Ambridge Rose – Outstanding RFI Coastal, Engineering and Acoustic items 4/11/202

Council Feedback	Further Response
Coastal Based on the Coastal Hazard Assessment (CHA) Report submitted, the coastal s92 response and associated draft conditions, sections of the proposed development fall seaward of the site-specific 100-year ASCIE line. In accordance with the requirements of the New Zealand Coastal Policy Statement (NZCPS) 2010, the applicant must include appropriate mitigation measures within this current application to address potential coastal instability and erosion hazards. Please confirm whether the applicant is including the in-ground palisade wall at the eastern section (referenced in the Geotech Report) as part of this proposal to address these identified hazards. If so, please ask that they provide details of its design and dimensions in relation to the identified erosion risks at the site	4DE Environmental and Tattico have reviewed this request and provided a further response which forms Attachment A. Updated conditions of consent are also proposed which form Attachment B to this Further Response. As noted in the original reports and further responses, an in-ground palisad

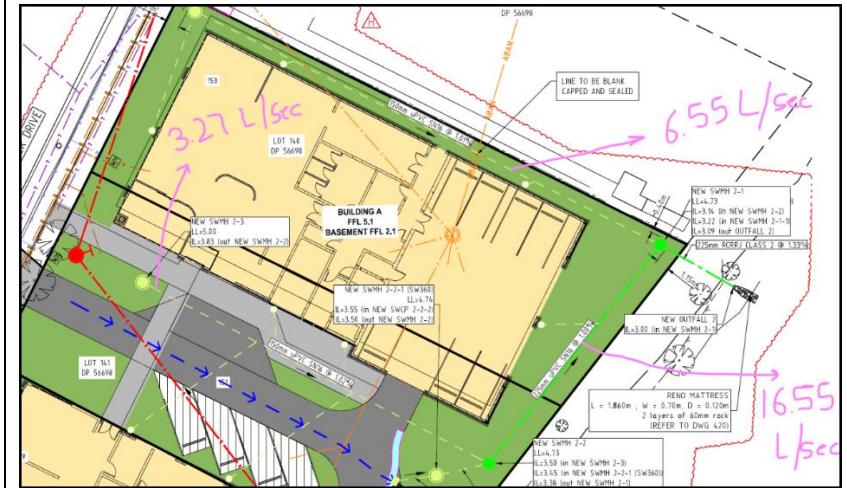
As per the attached spreadsheet, with the exception of item 6 all items have been closed out. The LDE response for item 6 said this would be addressed in the civil response but there was no response to this item in the civil report.

Everest have co-ordinated with LDE and the following response is provided:

"There is some spare capacity in the drainage lines. Please see snip below that shows the spare capacity of the pipes around the basement."

The volume of discharge from the basement is not currently known and can be assessed during the detailed design stage. A Hydraulic Engineer will need to be engaged to provide a drainage plan within the building footprint that provides information on the subsoil configuration and sizing, pump specifications and rising main size. The location of the basement sump will also need to be specified.

<i>The applicant is willing to accept a condition of consent requiring that this information be supplied during detailed design stage”.</i>
--	---
